Product Change Bulletin

Upgrade of Casters

04-01-2009

MiniMag, Magnum

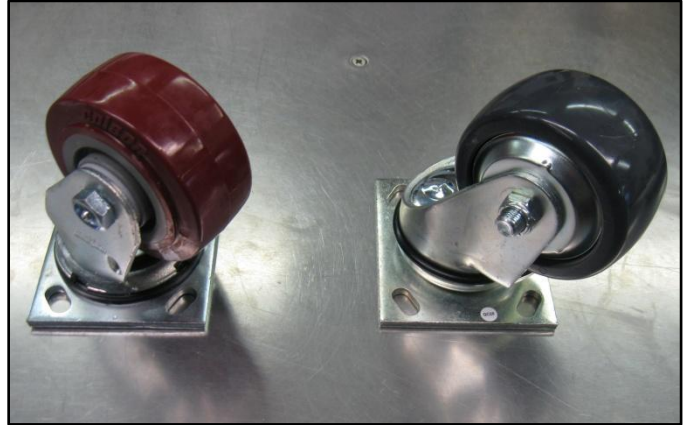
Strings or other thin long strands getting caught in caster, grease leaking, hard to turn machine.

We have upgraded the casters used on the MiniMag and Magnum scrubbers. The new casters now come with a stronger rubber seal to keep grease in, and also dust caps to prevent debris from getting into the bearings effecting performance and longevity. These provide easier steering and less rolling resistance fro pad assist machines.

To install new casters prop machine up onto a wooden block or something that will support the weight of the machine and will fit under the chassis. Remove the 5/16" bolts holding the caster on. Replace the old caster (190-3035) with the new caster (170-3030).
